CAMPUS WIDE, REPLACEMENT/REHAB SAN SEWER SYSTEM CAT 5.5
South Dakota State University
Brookings, South Dakota
OSE# R0323--03X/ARPA
2024

ADDENDUM NO. 1

November 6, 2024

SHEET NO.
1101

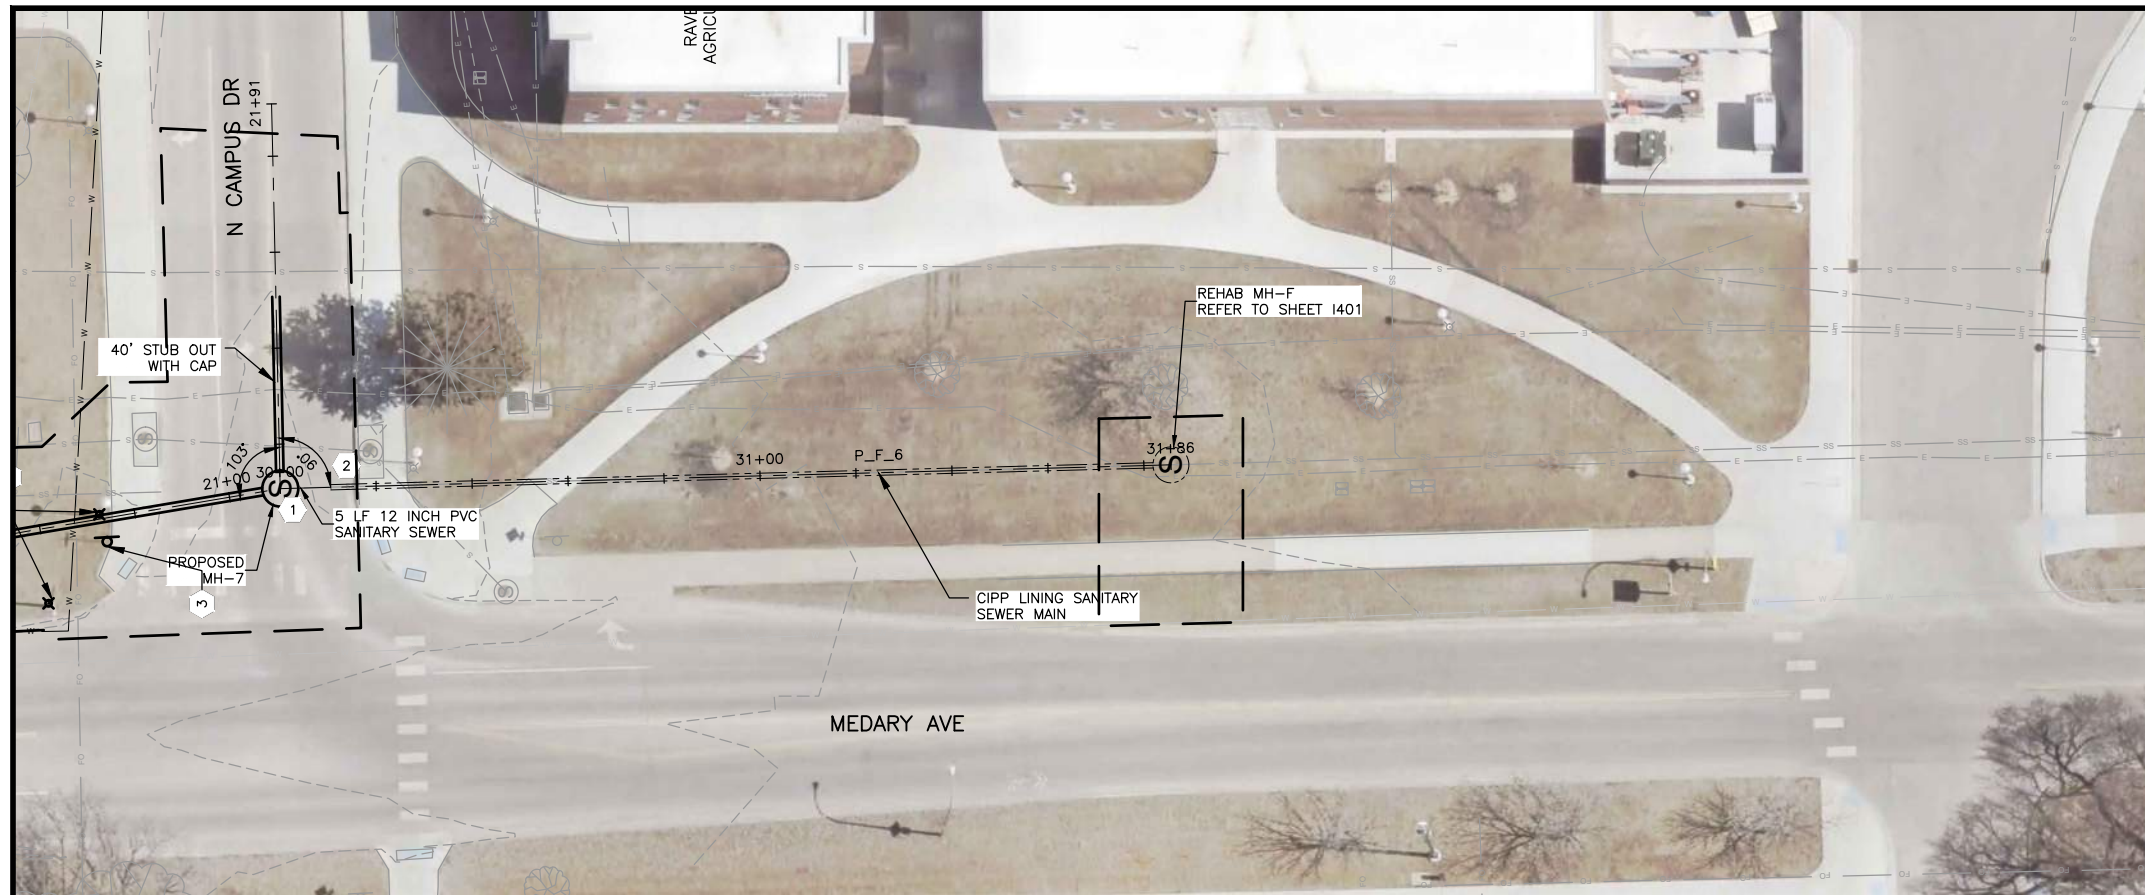
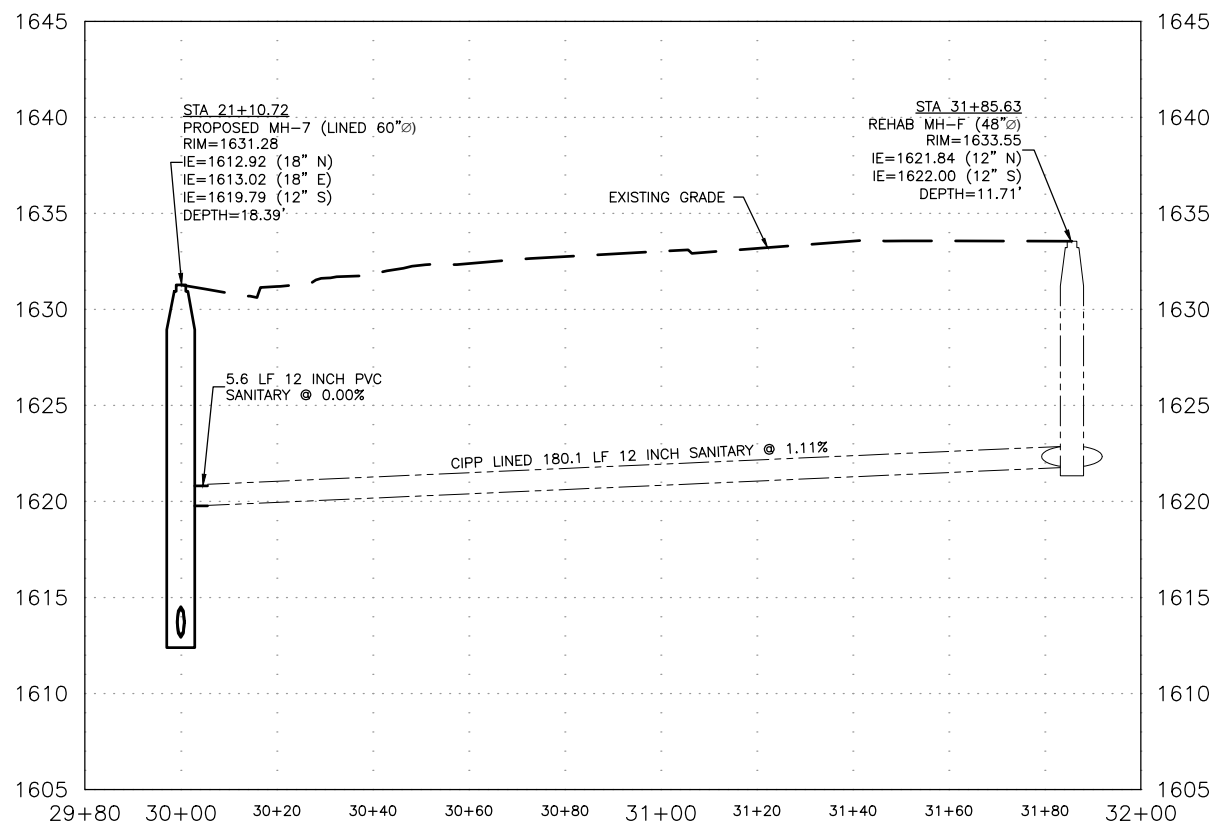
Modified call outs and keynotes.

SHEET NO.
1103

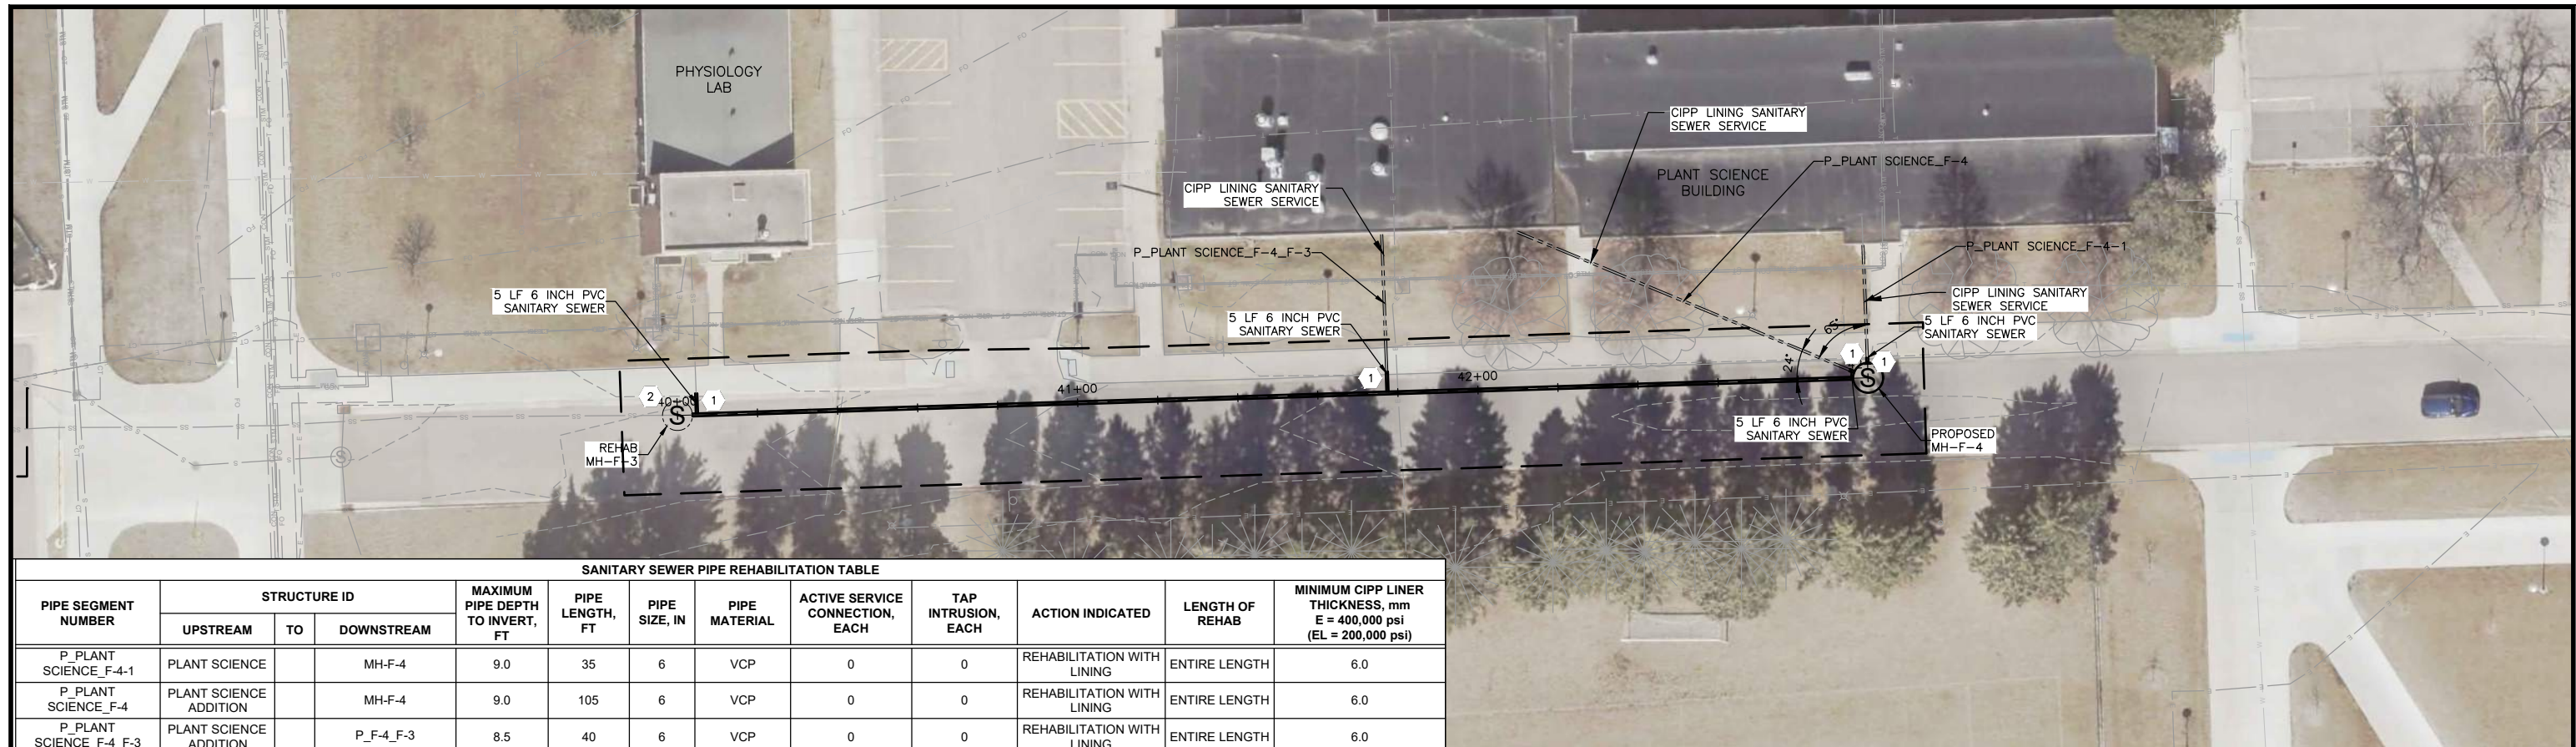
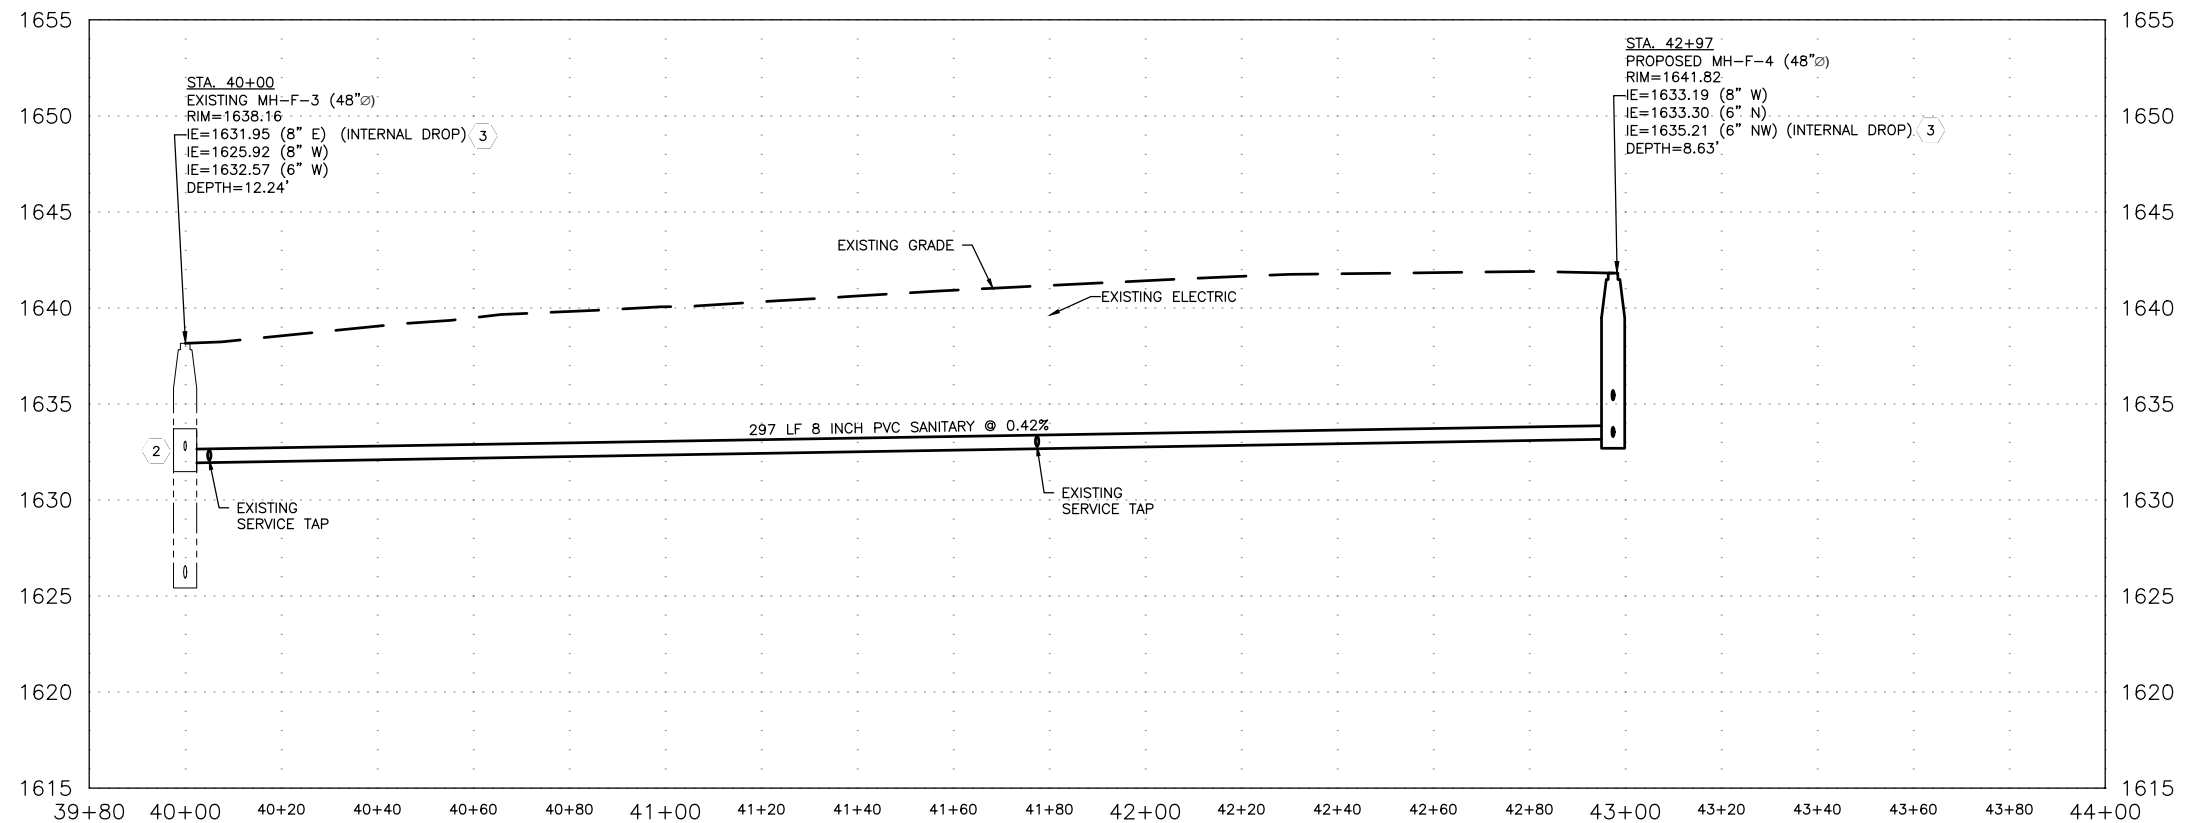
Modified call outs, keynotes, and rehabilitation table.

SHEET NO.
 1104

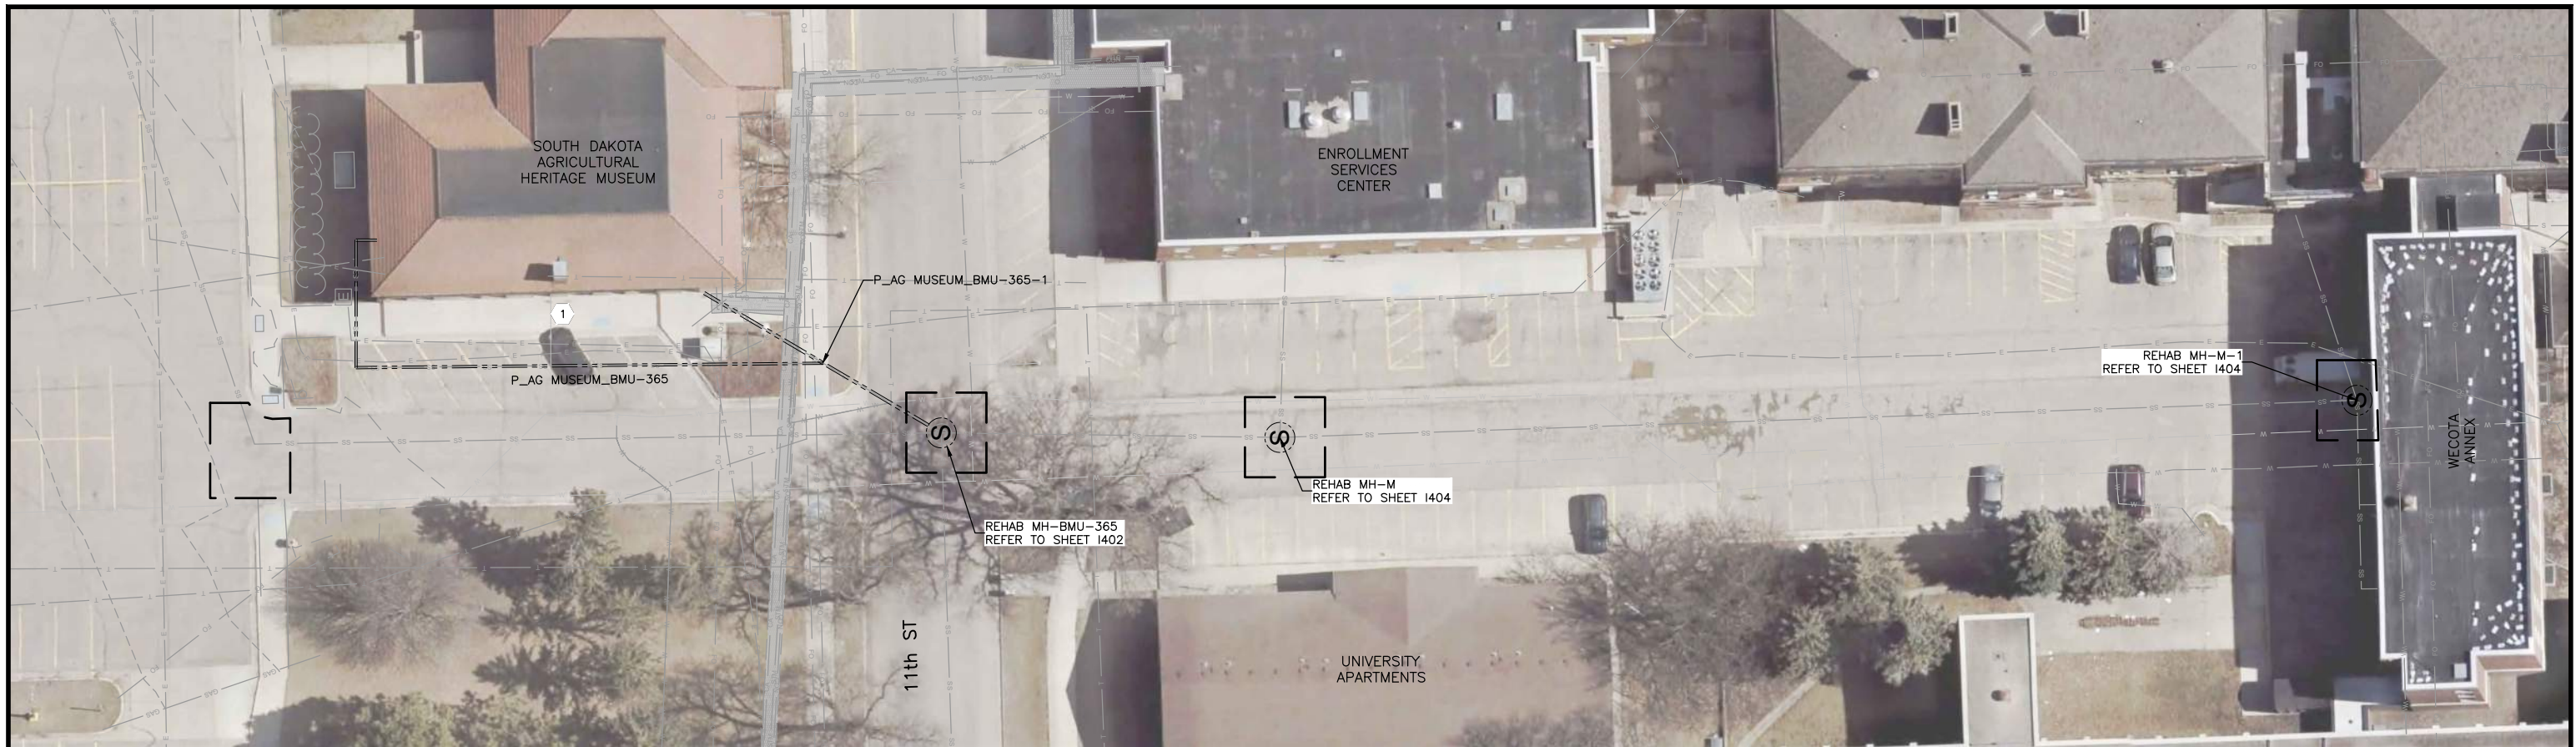
Modified call outs and keynotes.

SHEET NO.
 1105

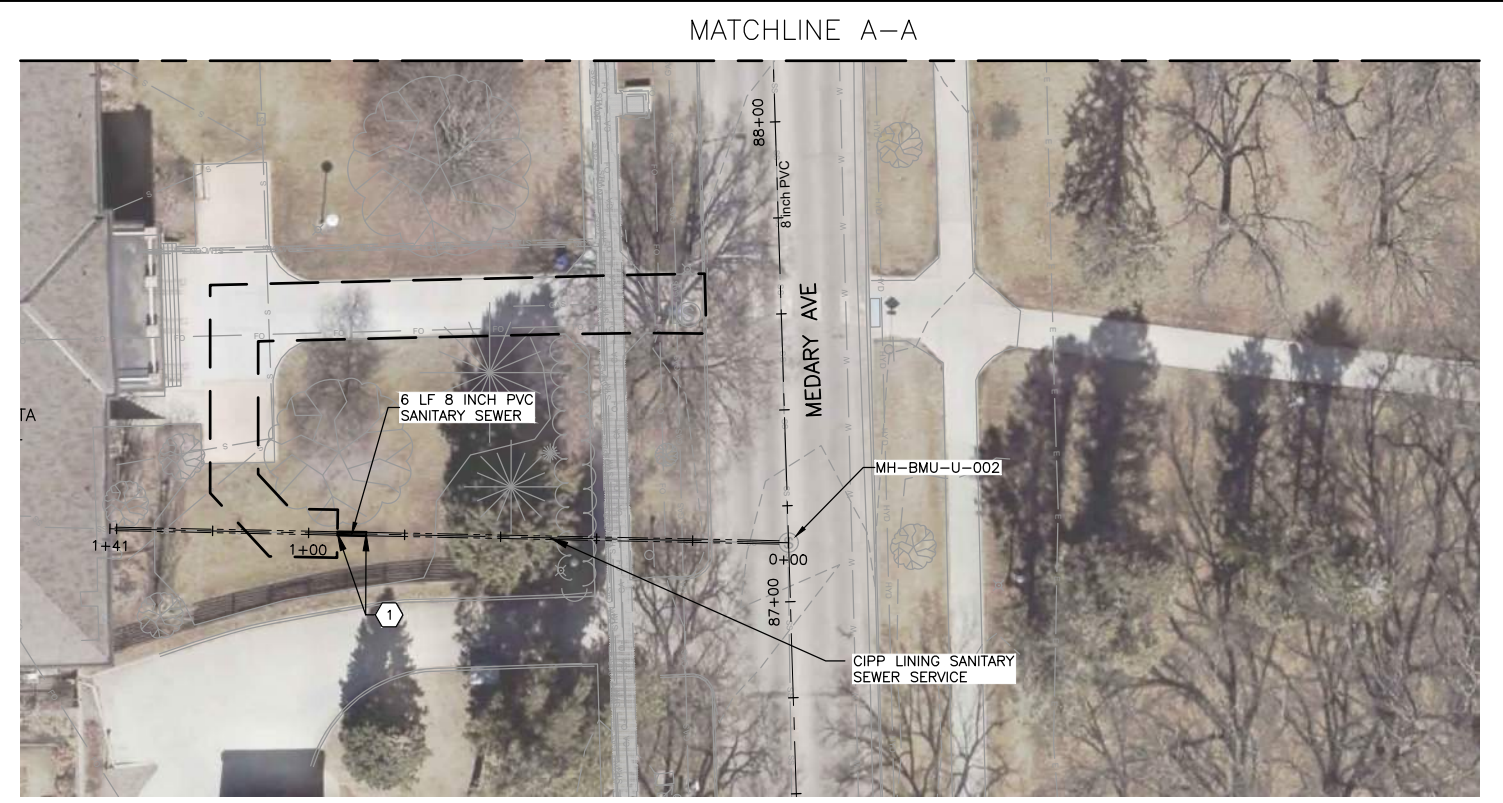
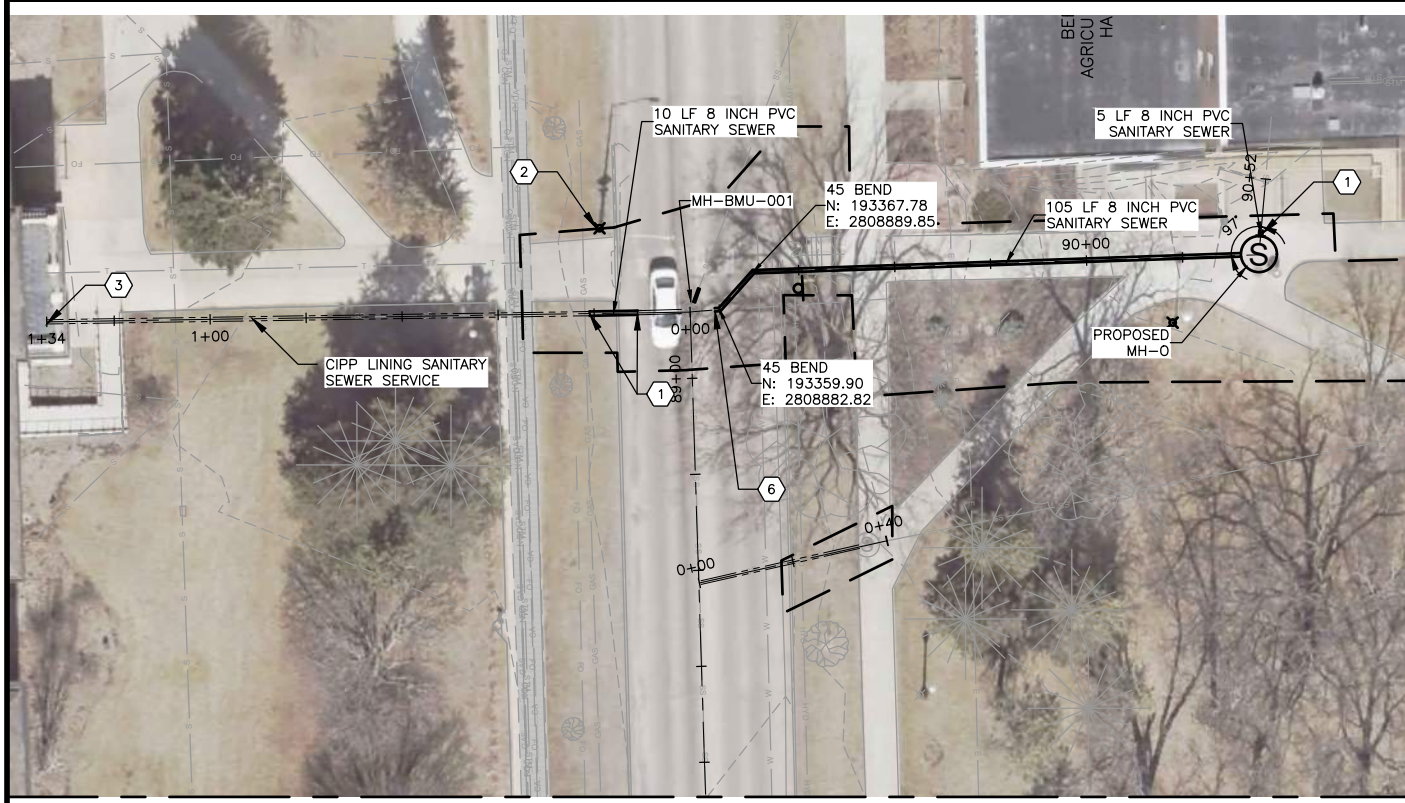
Modified call outs and keynotes.
